Comment Set F4 – Southern California Edison

Southern California Edison's West of Devers Upgrade Project Additional Material Yard Environmental Review

Responses to SCE Comments Related to Project Description Changes (Comment Set F4)

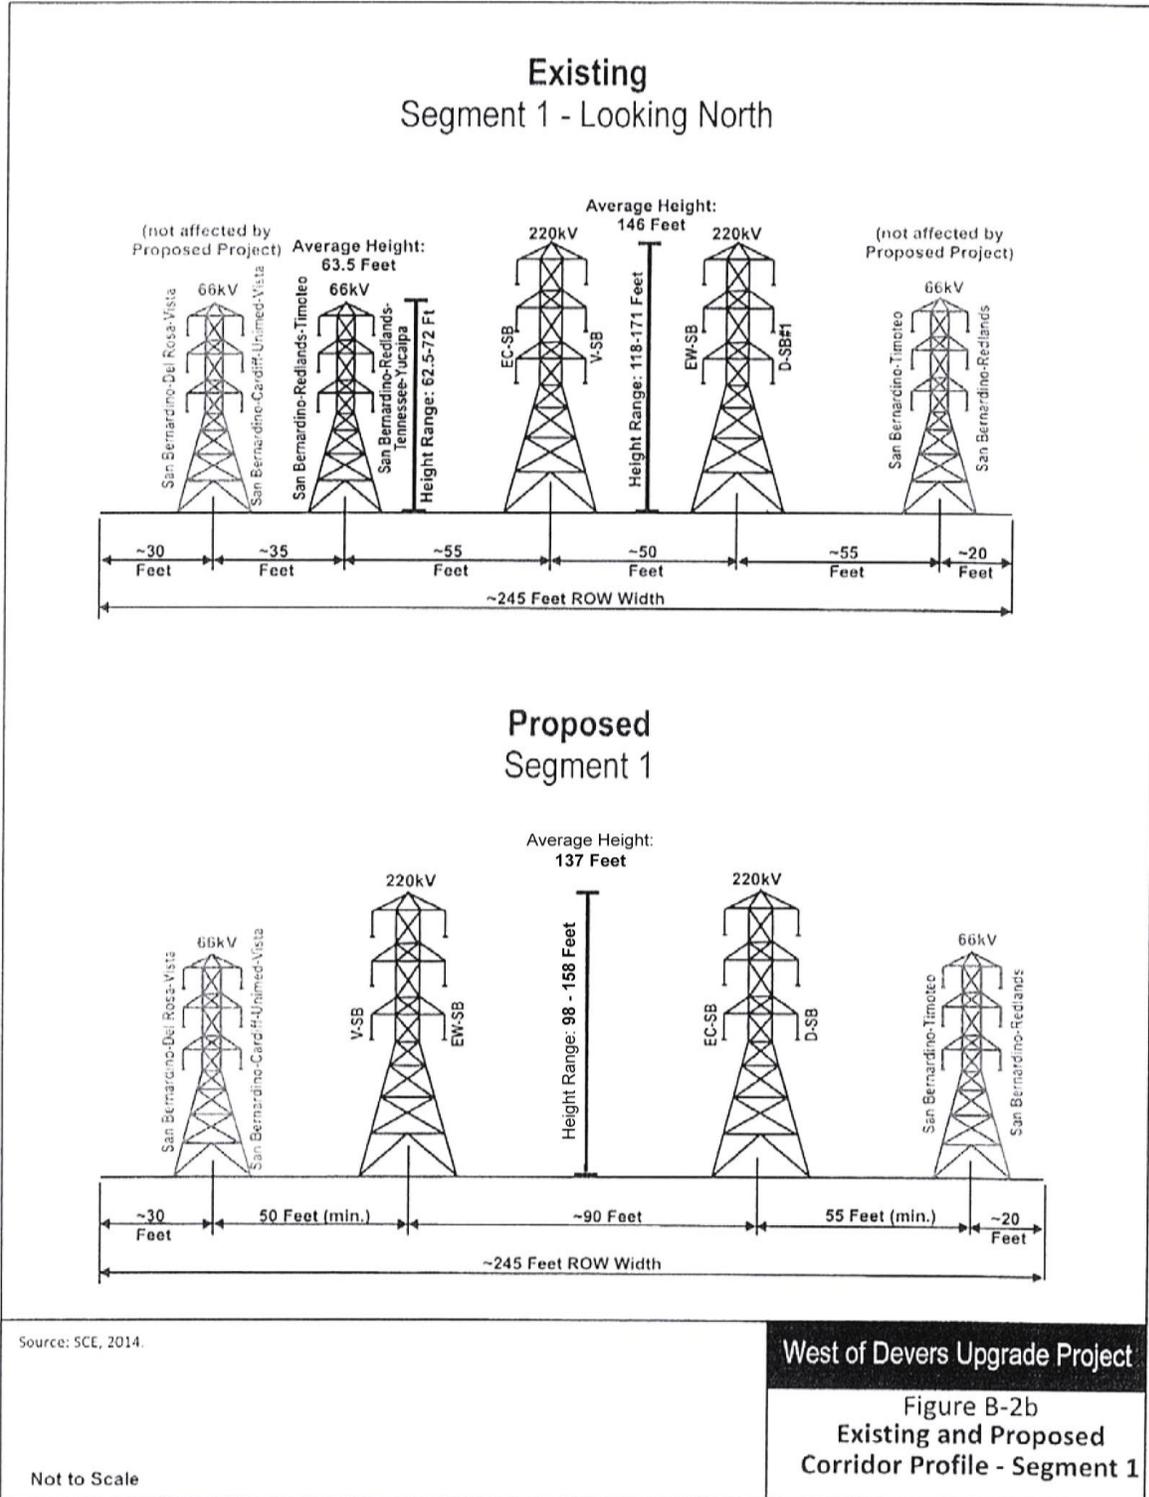
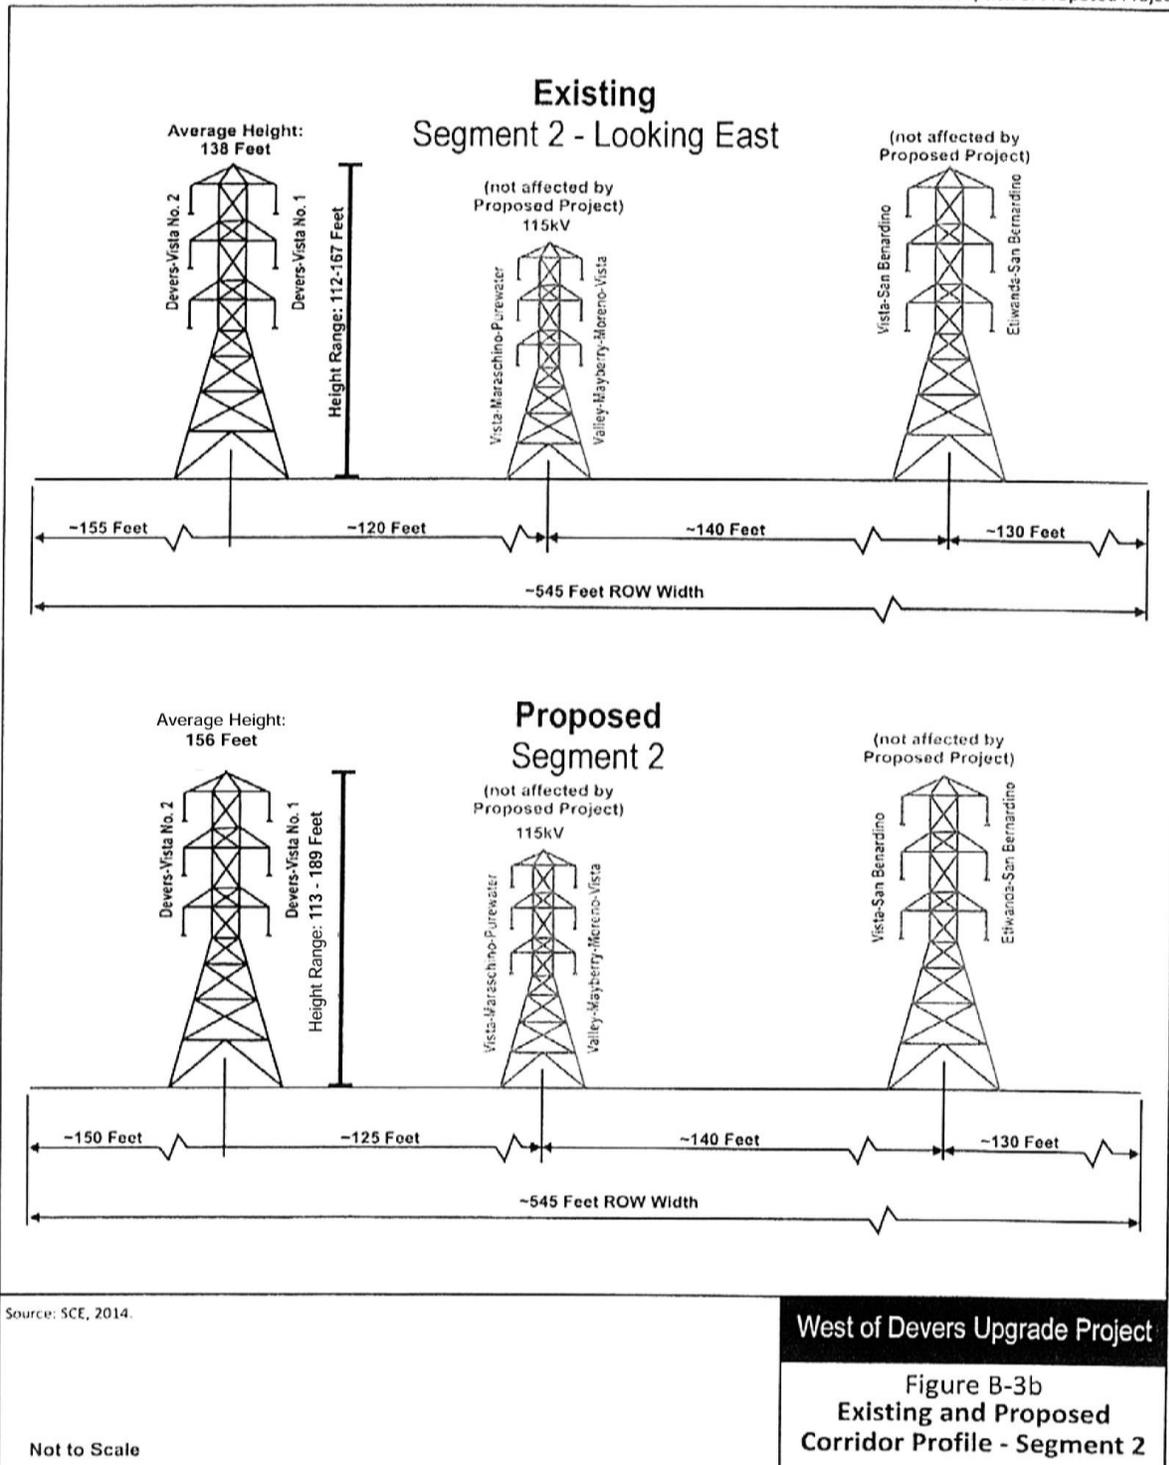
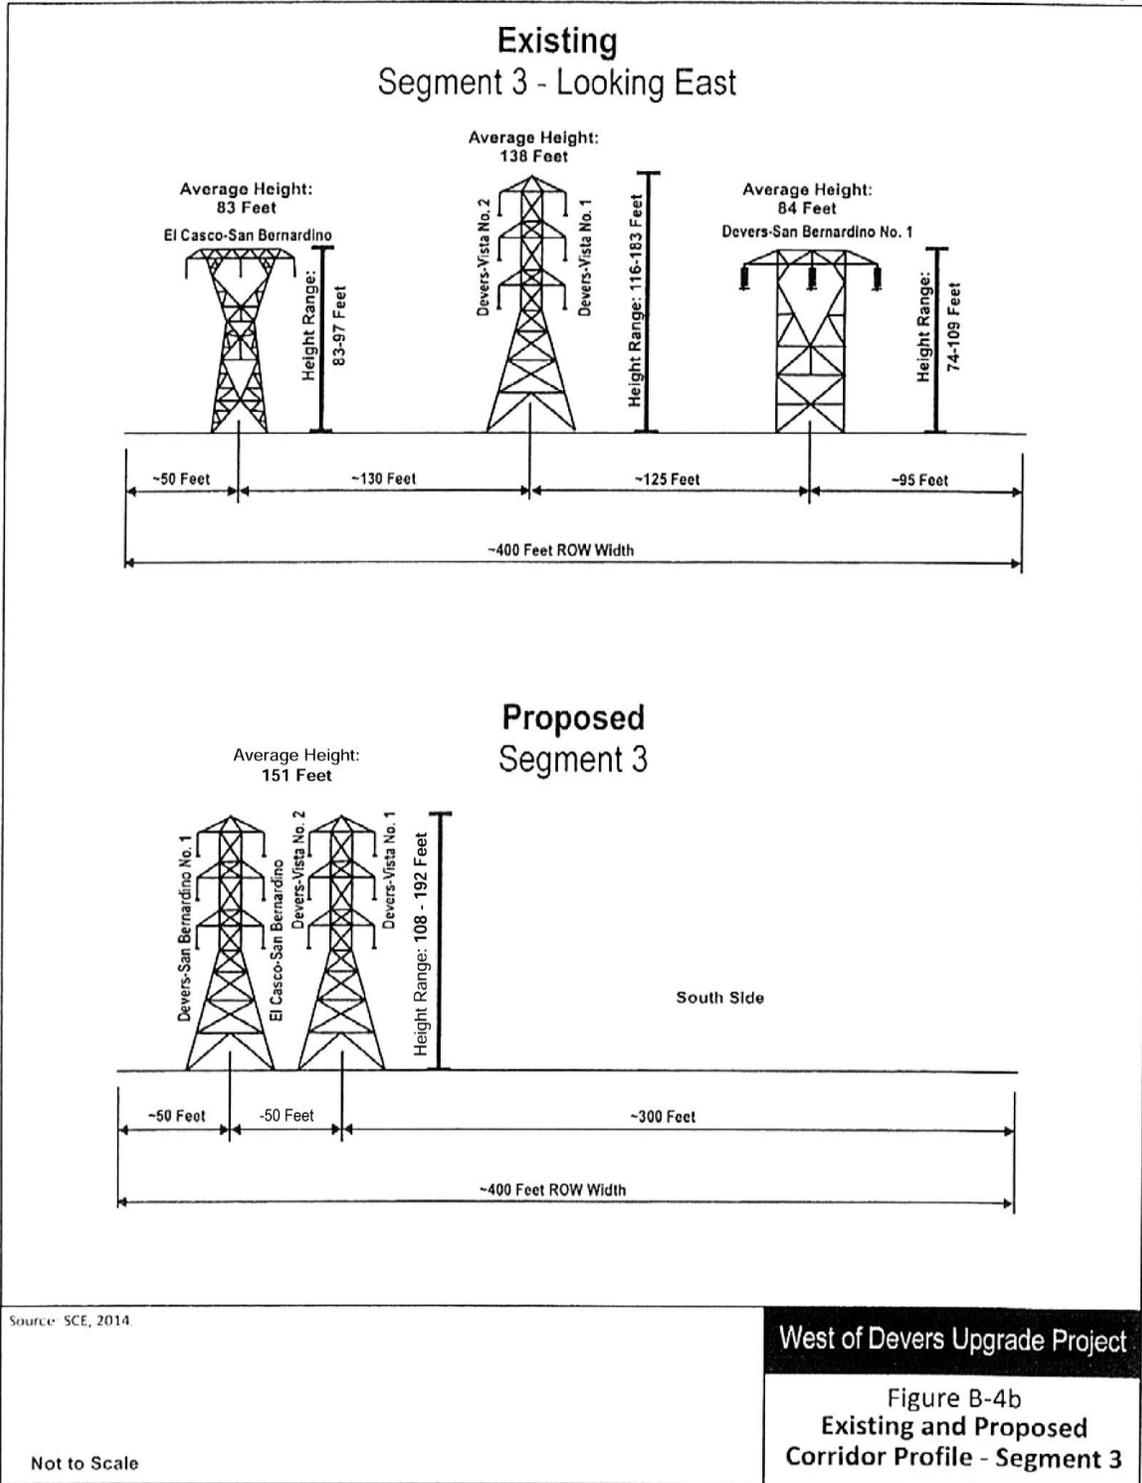
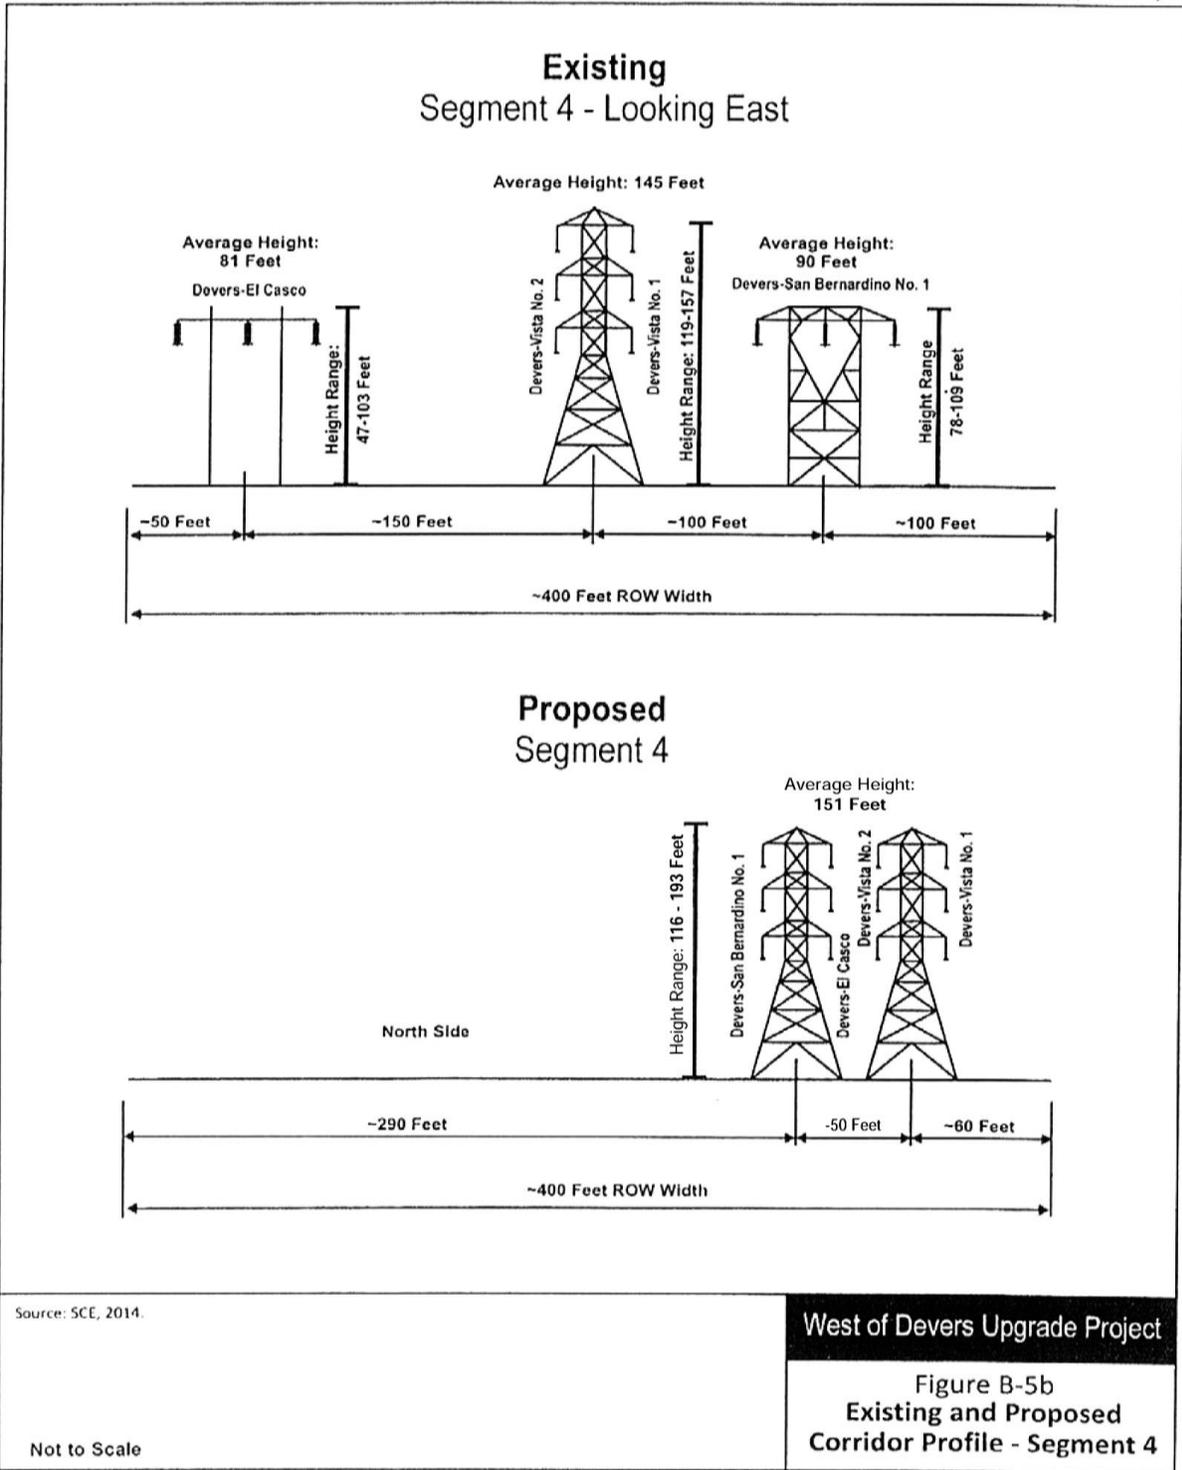
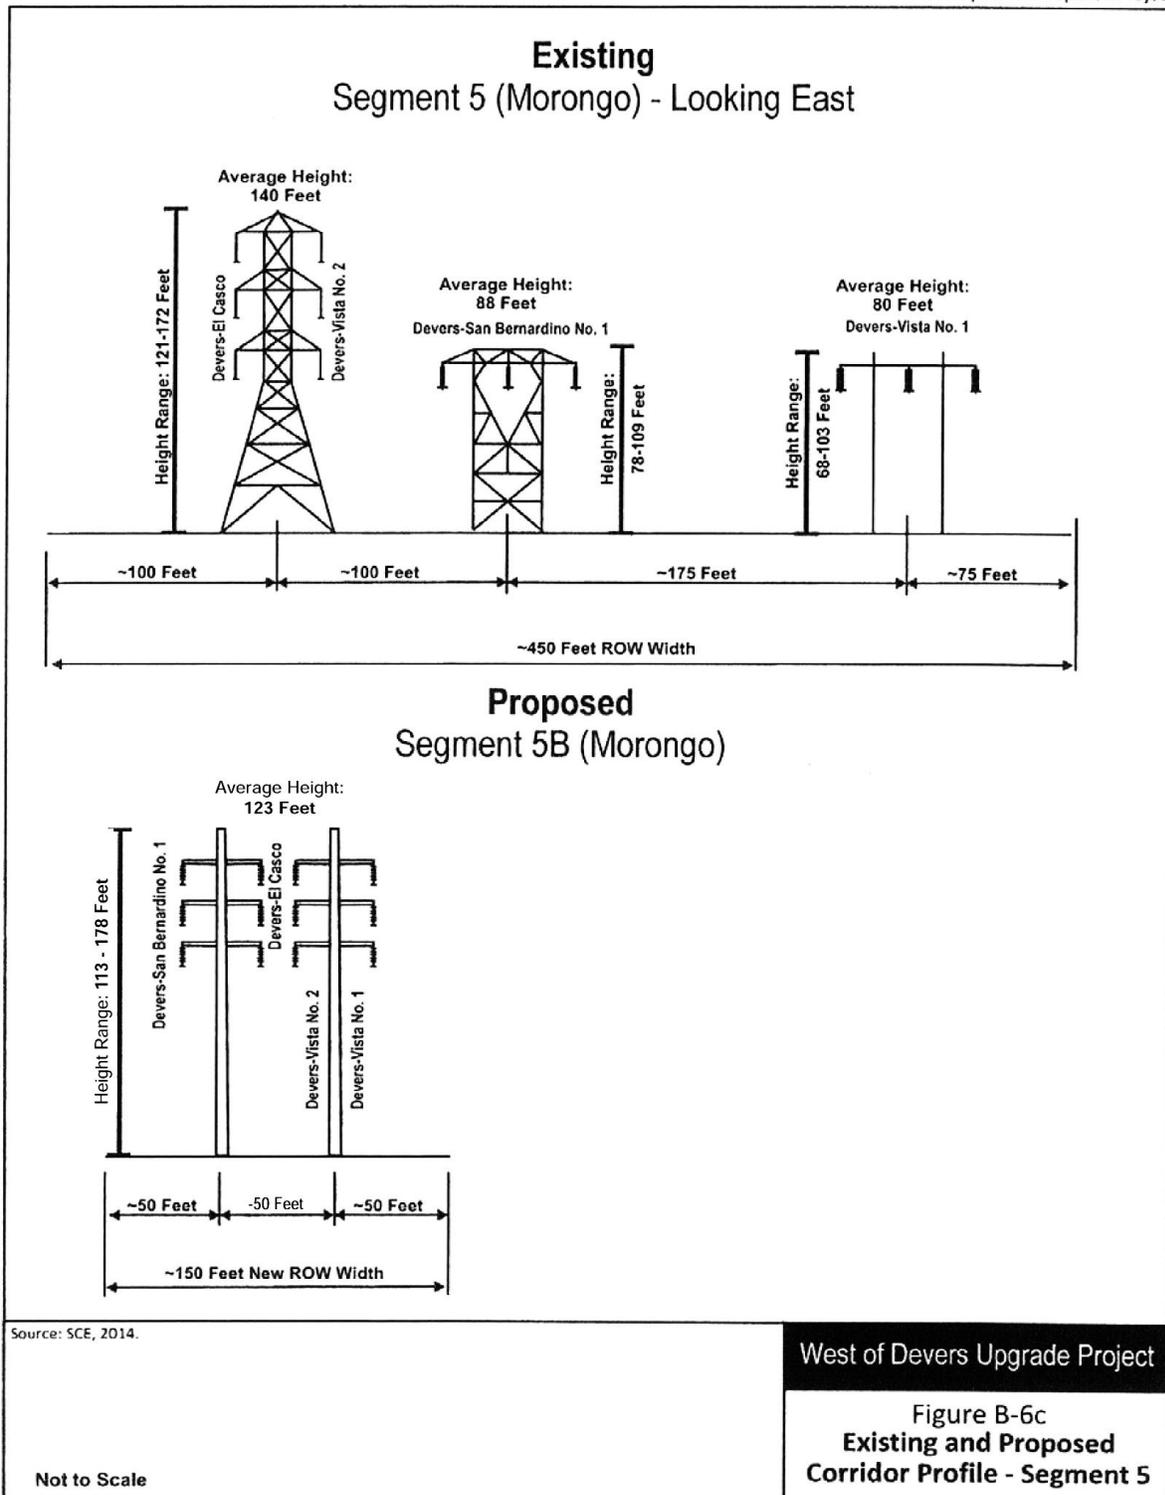
F4-4

F4-4
 cont.

F4-4
 cont.

F4-4
 cont.

F4-4
 cont.

- Figure B-2b (Existing and Proposed Corridor Profile – Segment 1),
- Figure B-3b (Existing and Proposed Corridor Profile – Segment 2),
- Figure B-4b (Existing and Proposed Corridor Profile – Segment 3),
- Figure B-5b (Existing and Proposed Corridor Profile – Segment 4),
- Figure B-6b (Existing and Proposed Corridor Profile – Segment 5),
- Figure B-6c (Existing and Proposed Corridor Profile – Segment 5), and
- Figure B-7b (Existing and Proposed Corridor Profile – Segment 6).

Figure B-6b
 Existing and Proposed
 Corridor Profile - Segment 5

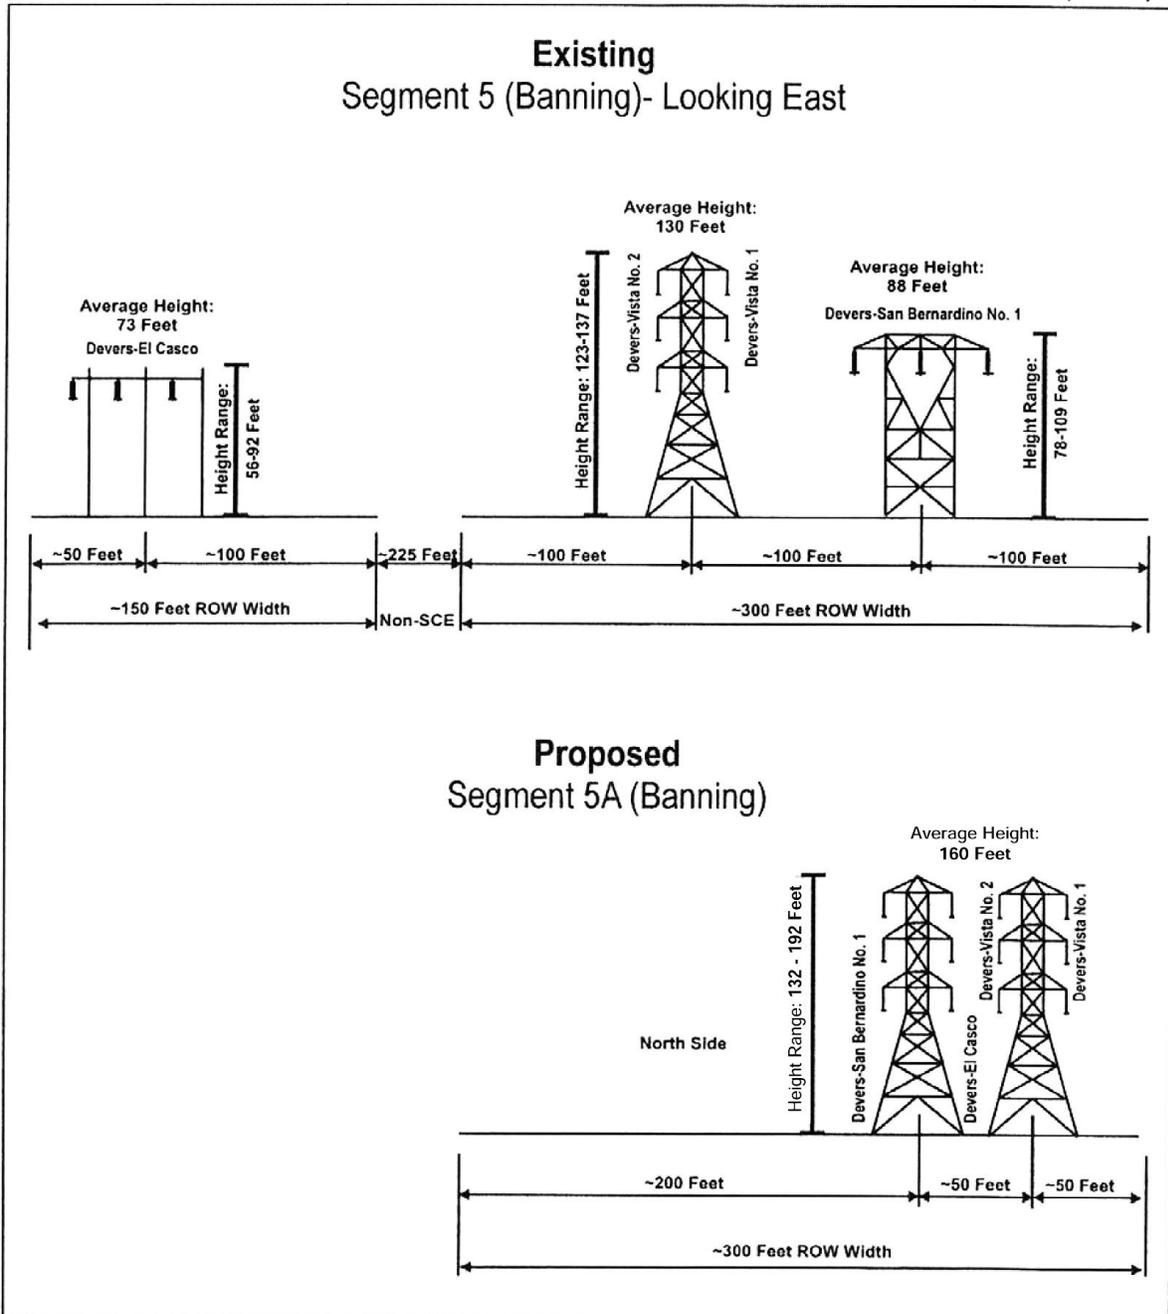
F4-4
 cont.
